# UNITED STATES PATENT AND TRADEMARK OFFICE

APPLICATION NO.	FILING DATE	FIRST NAMED INVENTOR	ATTORNEY DOCKET NO.	CONFIRMATION NO.
10/065,357	10/08/2002	Hatem Belfadhel	121123-1	5645
43248	7590	03/06/2006		
CANTOR COLBURN LLP - GE PLASTICS - SMITH 55 GRIFFIN RD SOUTH BLOOMFIELD, CT 06002			EXAMINER BOYKIN, TERRESSA M	
			ART UNIT	PAPER NUMBER
			1711

## Office Action Summary

### **THIS ACTION IS MADE FINAL**

*Figure 1*

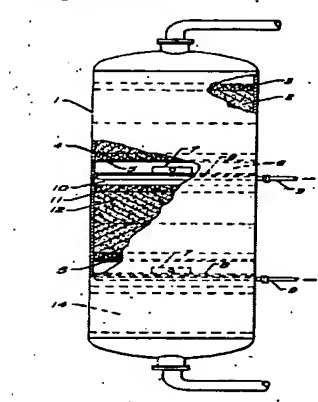
See also Figures 1, 3 and 4 may be envisaged using the language of applicant's claims.

**Claims 1-28 are rejected under 35 U.S.C. 103(a) as being unpatentable over USP 4669890 see abstract, figures 1, 3 and 4, cols. 3 –6 and claim 1.**

FIG. 1 shows a partially cutaway elevation view of a vertical flow contacting column having multiple beds of catalyst and mixing devices located between particle beds in accordance with this invention.

The claims simply state an "up flow reactor" with no specific limitations therein. Thus, it would have been obvious for one of ordinary skill in the art to manufacture a dihydroxy compound using the above reactor since it is disclosed therein that such a reactor may be used in condensation reactions and the like. Consequently, the claimed invention cannot be deemed as novel and accordingly is unpatentable.
